SUBJECT: Pilgrim Nuclear Power Station's Notification of Full Compliance with  
Order EA-12-051, Order Modifying Licenses with Regard to  
Requirements for Reliable Spent Fuel Pool Instrumentation

Pilgrim Nuclear Power Station  
Docket No. 50-293  
License No. DPR-35

PNPS Letter 2.15.051

**NRC Audit Questions and Status**

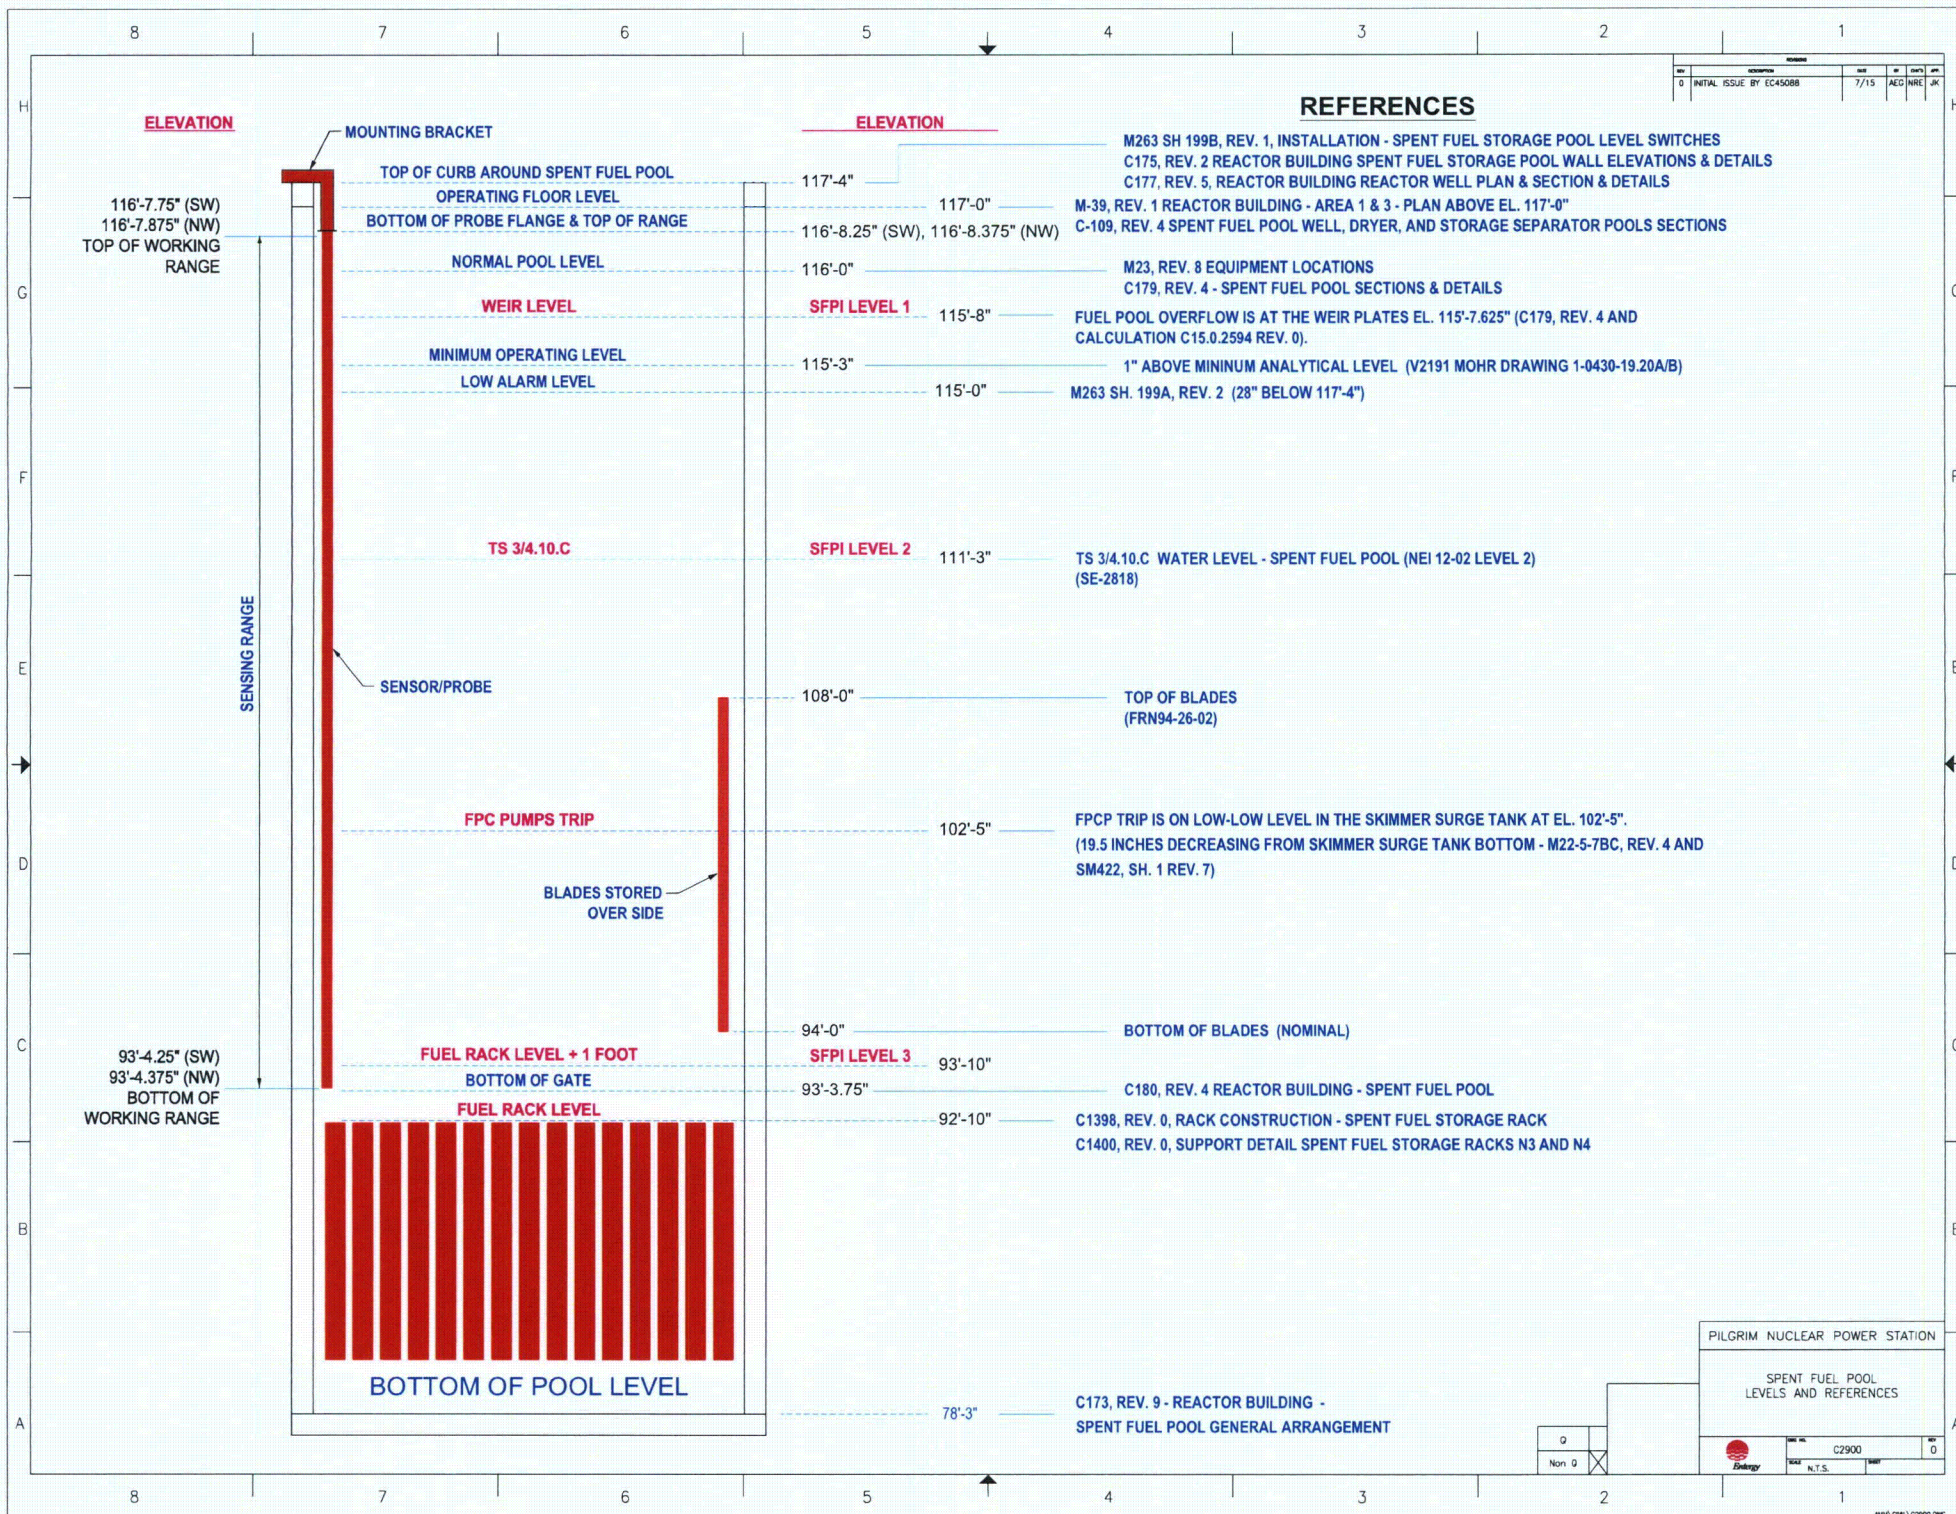
8-D	SFPLI RAI 8	Regarding RAI Number 7 above, provide the results for the selected methods, tests, and analysis used to demonstrate the qualification and reliability of the installed equipment in accordance with the Order requirements.	<p><b>CLOSED</b>  See answer to 7-D and the following documents.</p> <p>1-0410-9 "MOHR SFP-1 Level Probe Assembly Seismic Analysis Report"</p>

Audit item no.	Original Document Reference	Item	Status
			1-0410-16, "MOHR SFP-1 Level Probe Assembly Shock and Vibration Test Report"
9-D	SFPLI RAI 9	Provide analysis of the vendor analysis and seismic testing results and show that the instrument performance reliability, following exposure to simulated seismic conditions representative of the environment anticipated for the SFP structures at Pilgrim, has been adequately demonstrated.	<p>Acceptable, MOHR has prepared a series of seismic qualification reports for the SFP level instrument. The qualification reports envelop all components of the new SFP level instrumentation required to be operational during a BDBEE and post-event. These documents are MOHR Reports 1-0410-6 and 1-0410-9.</p> <p>Calculation C15.0.3625 was prepared in accordance with EN-DC-126 and accounts for seismic loads. It shows that the SFPI Probe Mounting Bracket is structurally adequate and seismically qualified as all Interaction Ratios (IR) are less than one (1.0). Acceptable, the MOHR seismic qualification reports in combination with NAI Report # NAI-1725-003 NAI Report # NAI-1725-004 and NAI-1725-003 adequately bound for the hydrodynamic loads associated with sloshing for PNPS.</p> <p>Calculation C15.0.3625 was prepared in accordance with EN-DC-126 and accounts for hydrodynamic loads and sloshing loads. It shows that the SFPI Probe Mounting Bracket is structurally adequate and seismically qualified as all Interaction Ratios (IR) are less than one (1.0). The NAI document is used as input to the bracket design.</p>
